TECHNICAL BULLETIN

V6 Coolant Pump Outlet Hose –
Replace With Correct Specification –
Service Action S518

MODEL 2004-05 MY
S-TYPE 3.0L

VIN N08089-N22276

ILLUSTRATION 1

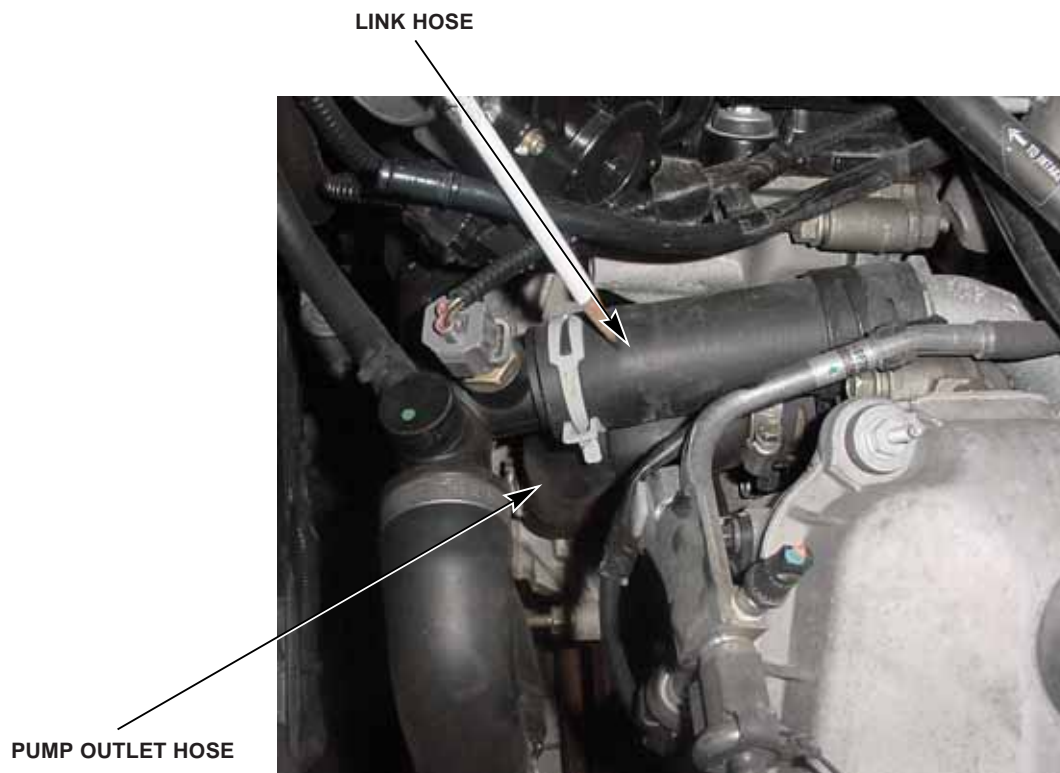
1. Open door, hood, and luggage compartment and install exterior vehicle protection.
2. Disconnect the battery, refer to Global Technical Reference (GTR), Workshop Procedure, section 414-01.
3. Raise the vehicle.
4. **Drain the coolant and set aside for reuse.**
5. Remove engine cover.
6. Remove the air cleaner outlet tube.
7. Disconnect the top hose from the link hose (Illustration 1).
8. Remove the link hose from the engine (Illustration 1).

ILLUSTRATION 2

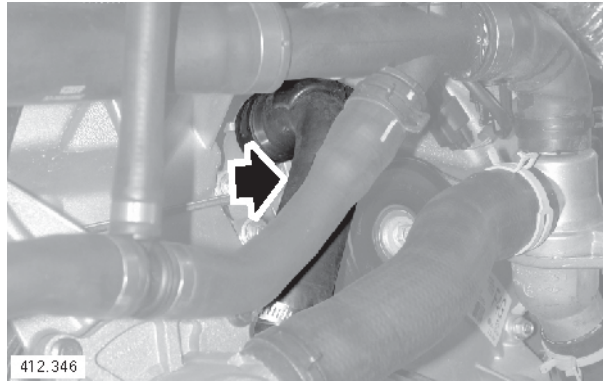
A concern has been identified on a number of 2004-05 MY S-TYPE 3.0L vehicles within the above VIN ranges. The coolant pump outlet hose installed in these vehicles may not be to the correct specification. This could result in the coolant pump outlet hose bursting causing the engine to lose coolant.

9. Disconnect the coolant pump outlet hose (Illustration 2) from the coolant pump.
10. Remove the coolant pump outlet hose from the engine.
11. Remove and set aside the two securing clips from the coolant pump outlet to engine hose.

12. Install the two securing clips on the new coolant pump outlet to engine hose.
13. Connect the coolant pump outlet hose to the engine.
14. Connect the coolant pump outlet hose to the coolant pump.
